IS350/250

OUTLINE OF NEW FEATURES

The following changes have been made for the 2011 model year.

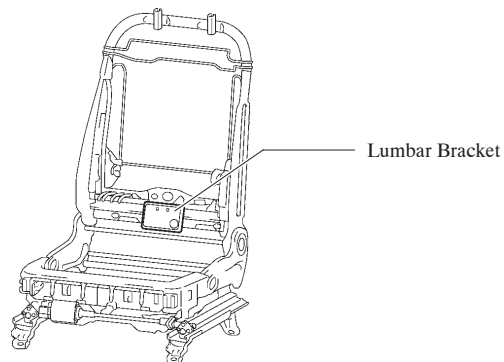
- The 17-inch aluminum wheel and 18-inch aluminum wheel design have been changed.
- Exclusive 18-inch aluminum wheels are installed on the F-SPORT package.

Tire Size	Front	205/55R16	225/45R17	225/40R18	
	Rear	205/55R16	P225/45R17 P245/45R17*2	255/40R18	
Wheel	Size	Front	16 × 7JJ	17 × 8J	18 × 8J
		Rear	16 × 7JJ	17 × 8J	18 × 8 1/2J
	Material	Aluminum	Aluminum	Aluminum	
P.C.D.*1	mm (in.)	114.3 (4.5)	114.3 (4.5)	114.3 (4.5)	
Inset	mm (in.)	Front	45 (1.8)	45 (1.8)	45 (1.8)
		Rear	45 (1.8)	45 (1.8)	50 (2.0)
Wheel Design					
Note		Carryover	Changed	Changed	New*3
